From: Richard Mazurkiewicz <RMAZURKIEWICZ@ramboll.com>
Sent: Friday, June 30, 2023 15:50
To: Moll, John G - DNR (Gregory)
Cc: Nick Orthmann; Kevin Kaiser; Daniel Petersen; Grittner, Paul V - DNR; Pfeiffer, Jane K - DNR
Subject: RE: Development at Historic Fill Site or Licensed Landfill Exemption Application, FS Apartments, LLC, BRRTS #07-41-589480
Attachments: F1 - New Concept Layout.pdf; F2 - Bio-Basin Detail.pdf; F3 - SL Base Map w Borings.pdf

From: Moll, John G - DNR (Gregory) <john.moll@wisconsin.gov>
Sent: Friday, June 23, 2023 12:45 PM
To: Richard Mazurkiewicz <rmazurkiewicz@ramboll.com>
Subject: Development at Historic Fill Site or Licensed Landfill Exemption Application, FS Apartments, LLC, BRRTS #07-41-589480

The DNR has completed a preliminary review of the *Development at Historic Fill Site or Licensed Landfill Exemption Application* (Application) for the FS Apartments, LLC site (BRRTS #07-41-589480). To help with our review, we are requesting additional information to address the following items:

FIGURE 1

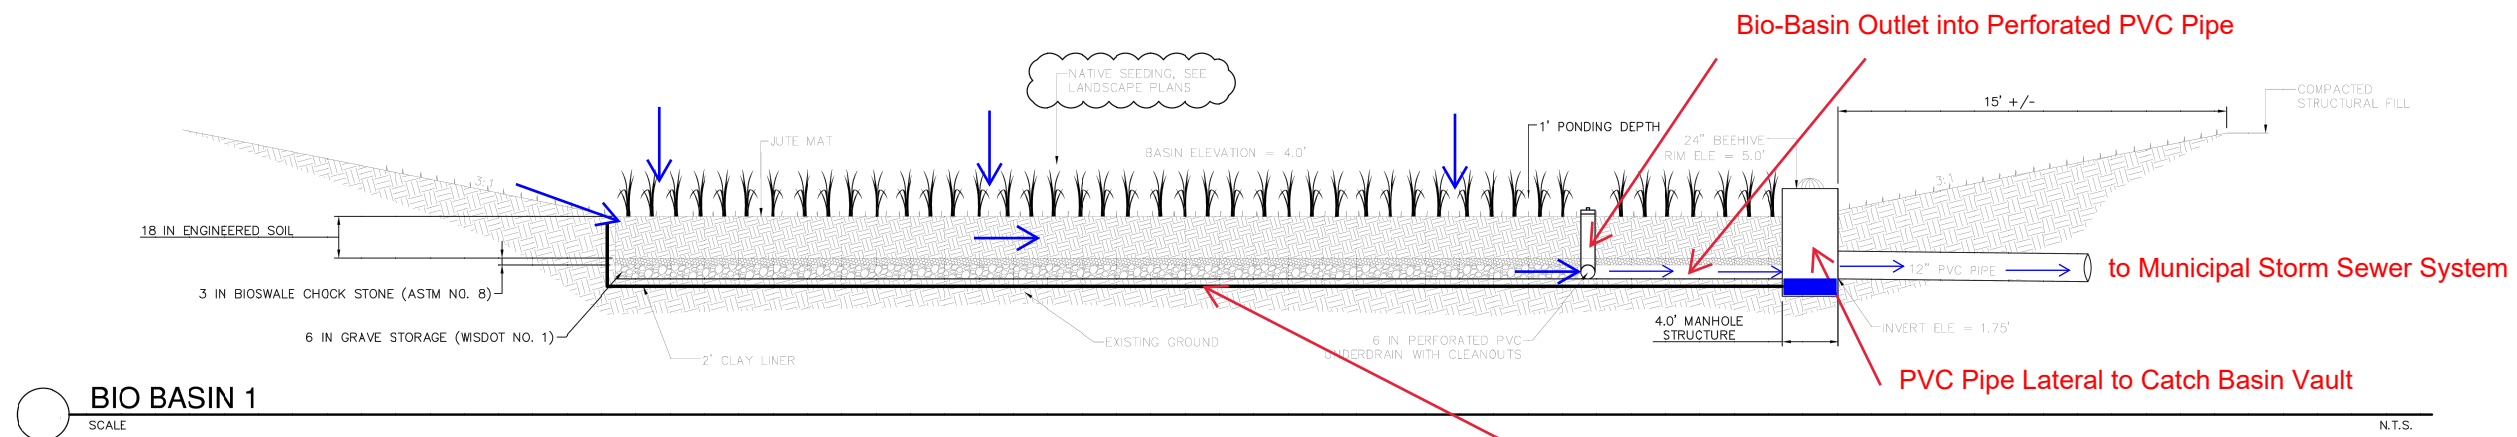
2. Two proposed stormwater basins are shown in Figures 17 and 18 of the Application, however, the basins are not described in the Application. Describe the basin construction and design details.

The two bio-basins (see attached Figure 1), will be lined with 2 feet of compacted clay, the basin overflow goes to a slotted PVC pipe, which is diverted to a catch basin, and then enters a 12-inch PVC storm sewer (see bio-basin detail attached Figure 2). The bio-basins do not leach back into the historical urban fill.
